## **Arlington Zoning Board of Appeals**

**Date:** Tuesday, October 25, 2022

4. Docket # 3715: 39 Woodside Lane (Continuance)

RE: Docket 3715 – 39 Woodside Lane; Special Permit under Zoning Bylaw 5.4.2.B(6) Districts

DRAWING NUMBER:

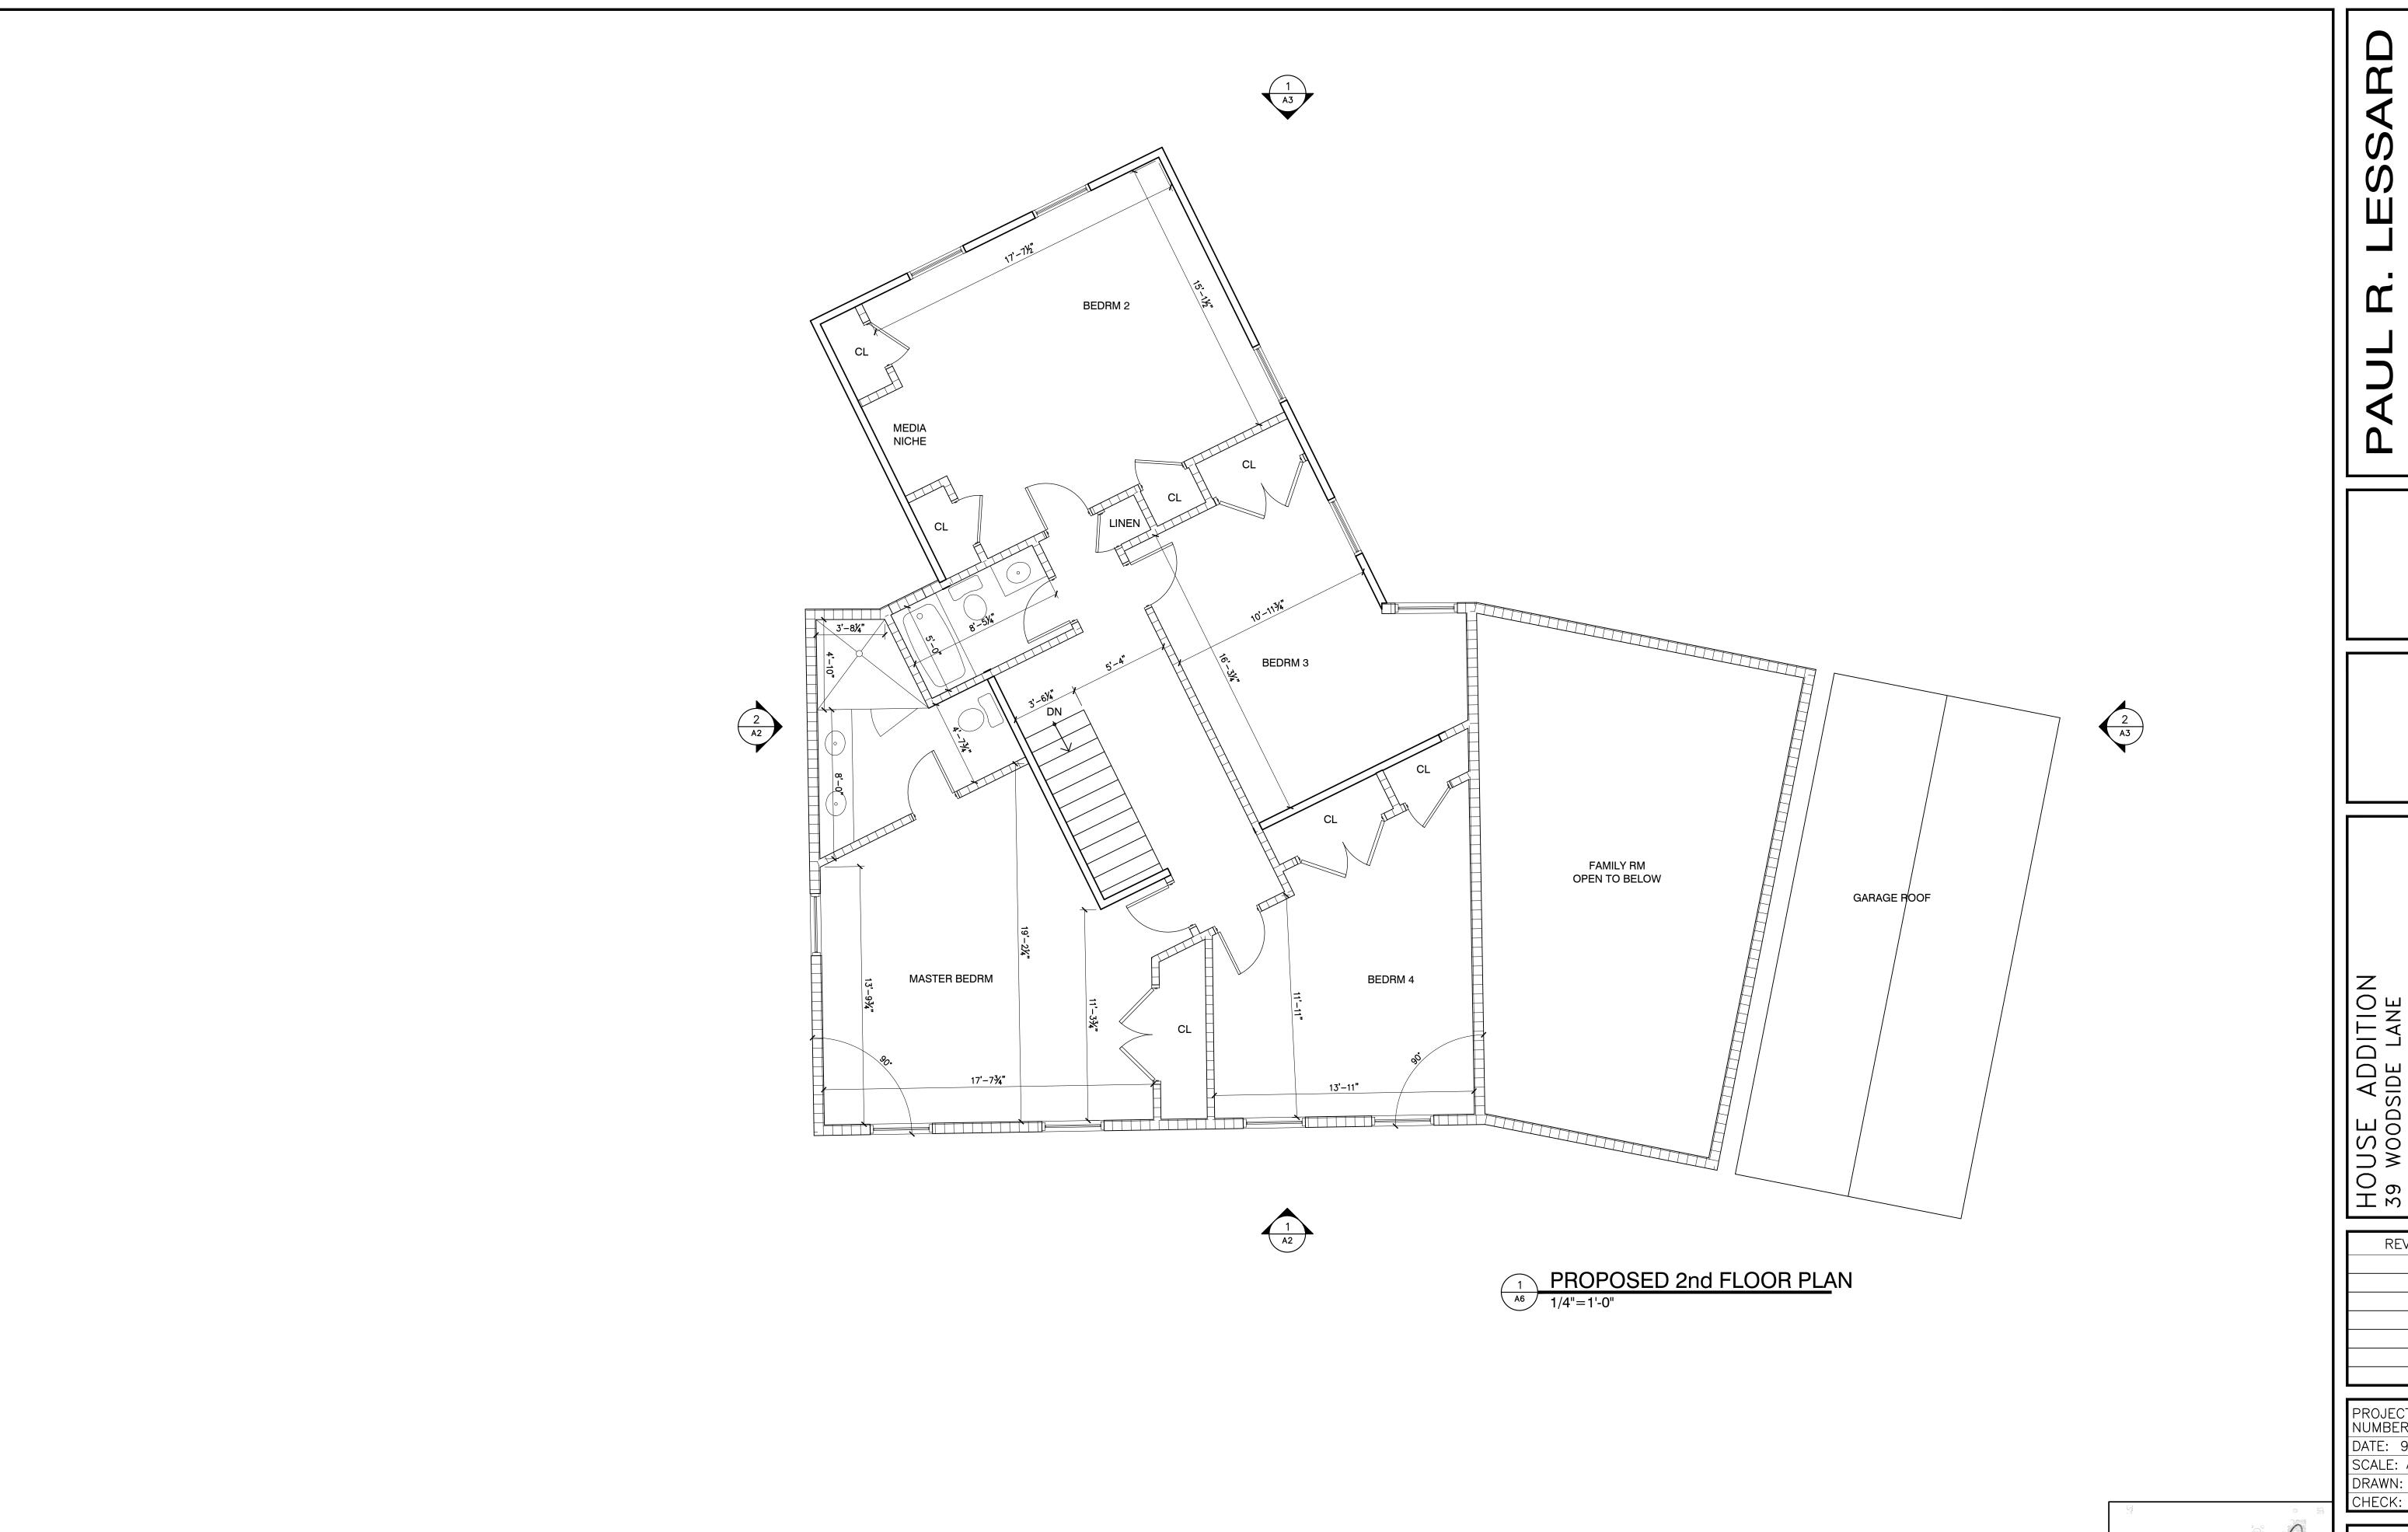
The application states the proposal would increase the gross floor area of the attic to 769 SF (+431 SF). Per the definition of a half story in Section 2 (Definitions) of the Zoning Bylaw, "less than one half of the floor area measured from the underside of the roof framing to the finished floor below has a clear height of 7 feet 0 inches or more." It is unclear based on the materials submitted by the applicant whether a half story is proposed and if so, whether the dimensions of the finished floor area would comply with this definition.

DPCD recommends that the Zoning Board of Appeals (ZBA) requests that the applicant provide attic floor plans to clarify dimensions of the finished floor area and side elevations.
